MONTICELLO NUCLEAR GENERATING PLANT
Docket No. 50-263 License No. DPR-22
License Amendment Request
Elimination of Local Suppression Pool Temperature Limits

License Amendment Request Elimination of Local Suppression Pool Temperature Limits

Draft Changes to the Monticello USAR

FIGURE A
PLAN VIEW OF 3 MITERED SECTIONS
OF SUPPRESSION CHAMBER
 (NOTE: OTHER INTERNAL STRUCTURES NOT SHOWN FOR CLARITY)

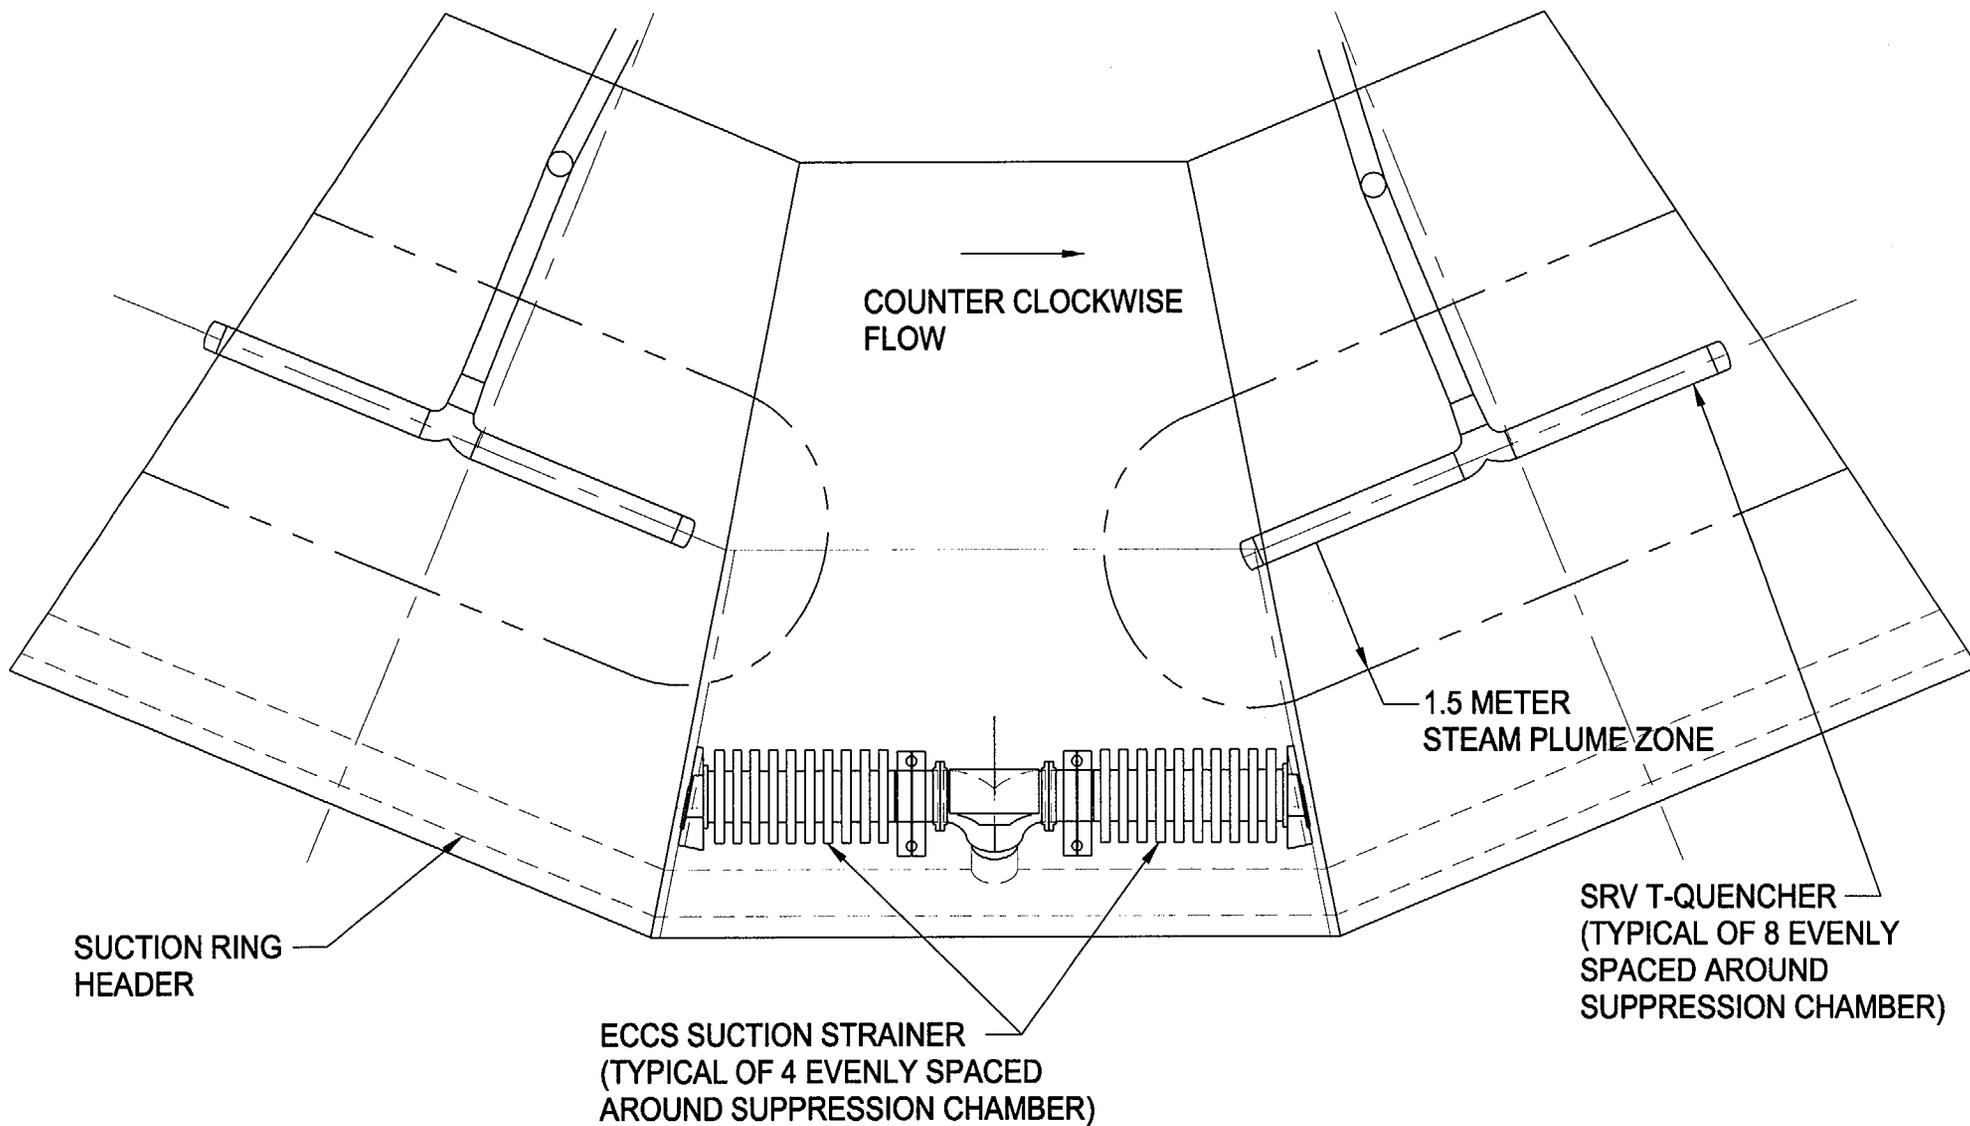
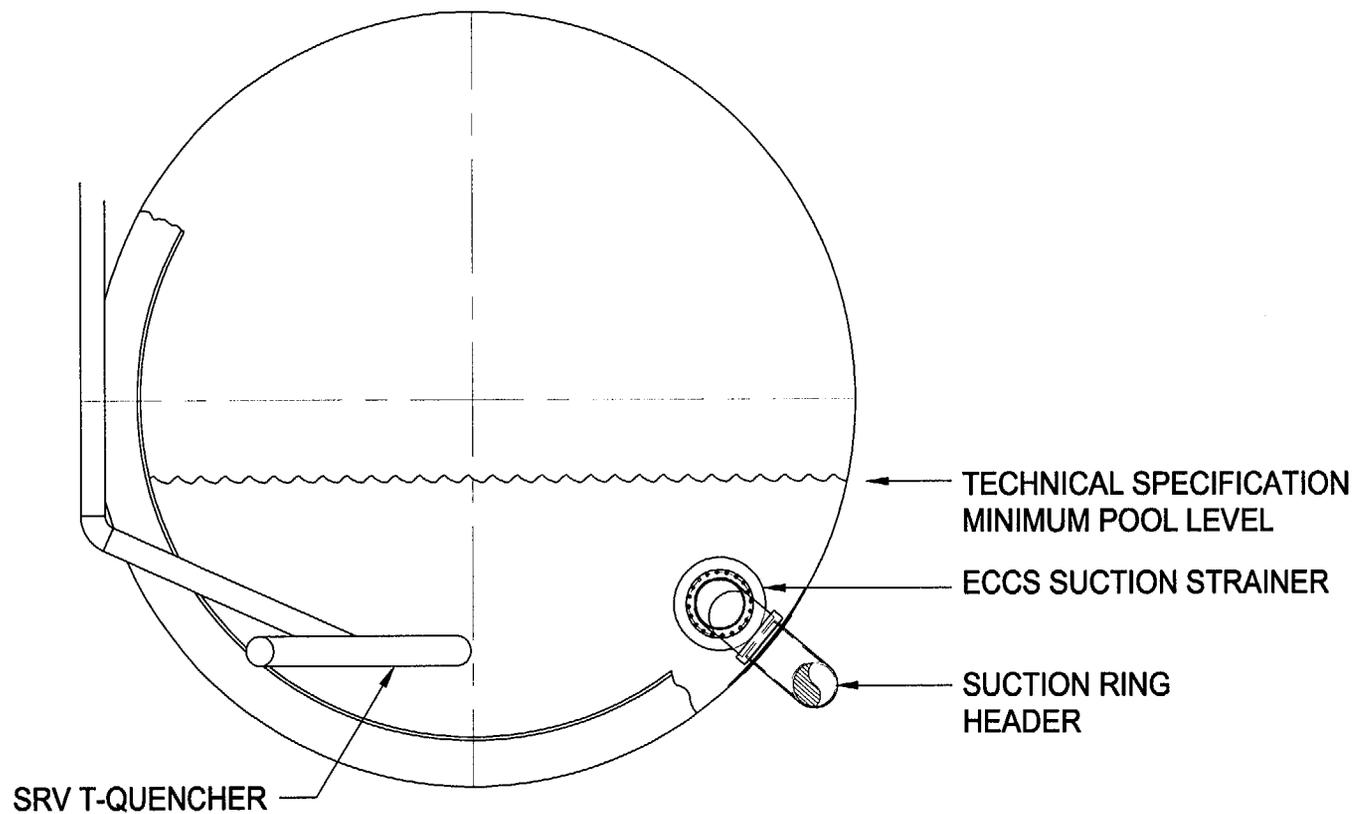
After Reference 6 was issued, the Monticello ECCS suction strainers were replaced with much larger strainers. However, the physical inlet to the ECCS was not changed. Instead of a small strainer in the middle of a bay, the new suction strainers extend the entire length of the bay without a T-quencher, as shown in Figure A attached. Prior to the modification, the small suction strainers were at approximately the same elevation as the T-quenchers. Following the modification, the top elevation of the new suction strainers is approximately two feet above the T-quencher elevation, as shown in Figure B attached. It should be noted that the ECCS inlet elevation was not changed. Although the elevation of the suction strainers entrance is above that of the T-quenchers, the lateral distance exceeds the 1.5 meters considered by BNL as a reasonable and conservative estimate of the maximum lateral extent of any steam plume, see attached Figure A for 1.5 meter zone around T-quenchers. Therefore, the physical separation between the T-quenchers and ECCS suction strainers is adequate to prevent steam ingestion if there were saturated conditions in the suppression pool with an extended discharge of an SRV.

As stated above the physical separation of the T-quenchers and ECCS suction strainers would preclude ingestion of a steam plume if saturated conditions were to exist in a stagnant pool. However, the Monticello T-quenchers were designed with holes in one end cap to promote a counter clockwise flow in the suppression pool. If the conditions for a steam plume were to exist, a counter clockwise flow would cause a steam plume to drift in the direction of an ECCS strainer (see Figure A). Since all of the ECCS pumps take suction from a common ring header which is connected to the four ECCS suction strainers, there is a very small suction flow field to attract a steam plume. For example, with HPCI running at 3000 gallons per minute (6.7 cubic feet per second) and a combined circumscribed surface area of approximately 600 square feet for the ECCS suction strainers, the approach velocity at the surface of each suction strainer would be approximately 0.01 foot per second. With such a small approach velocity at the ECCS suction strainer and the fact that a steam plume would be rising by several orders of magnitude faster, the likelihood of a steam plume being ingested in an ECCS strainer is extremely remote.

~~DELETED~~
Figure 5.2-24 ~~NRG Specified Local Pool Temperature Limit Based on NUREG 0783 for~~
~~Monticello~~

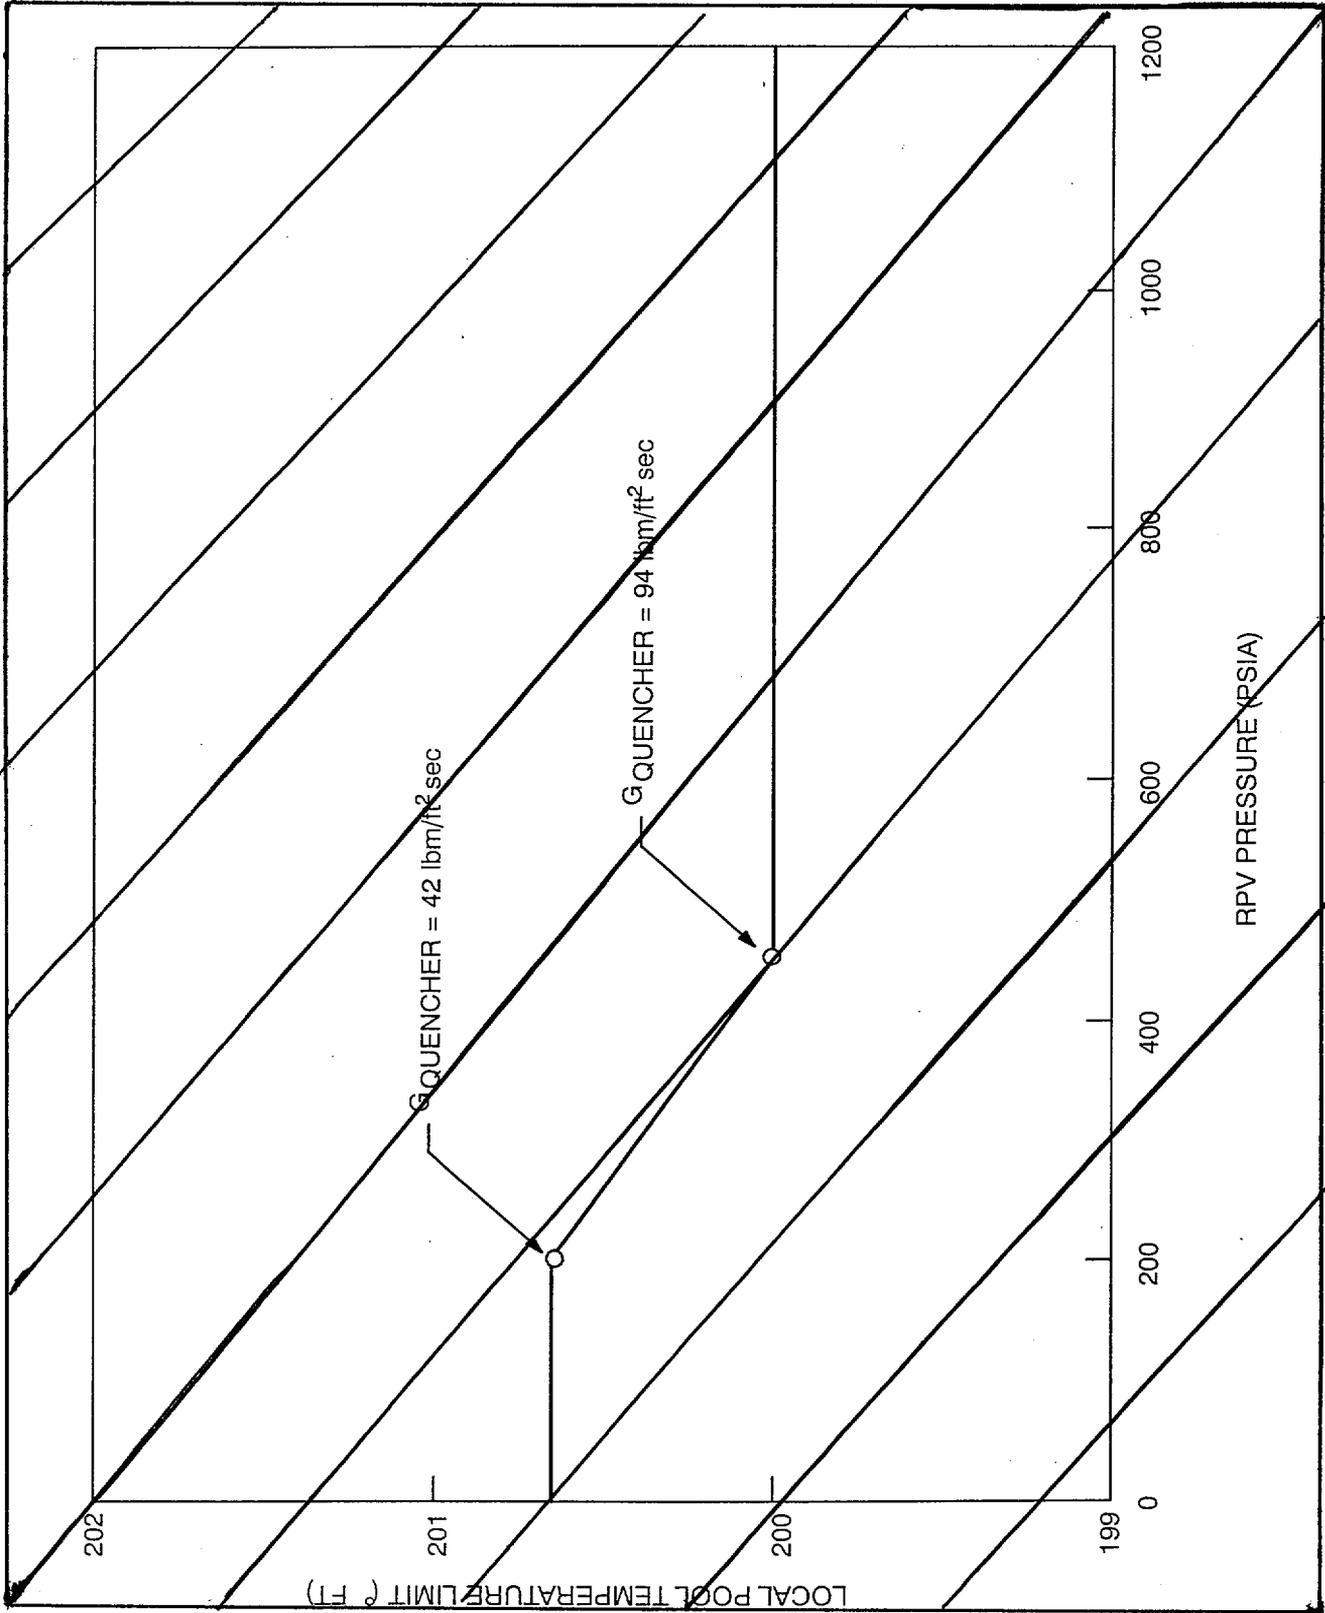
The NRC suppression pool local temperature limits for Monticello are plotted versus reactor vessel pressures and are shown in Figure 5.2-24.
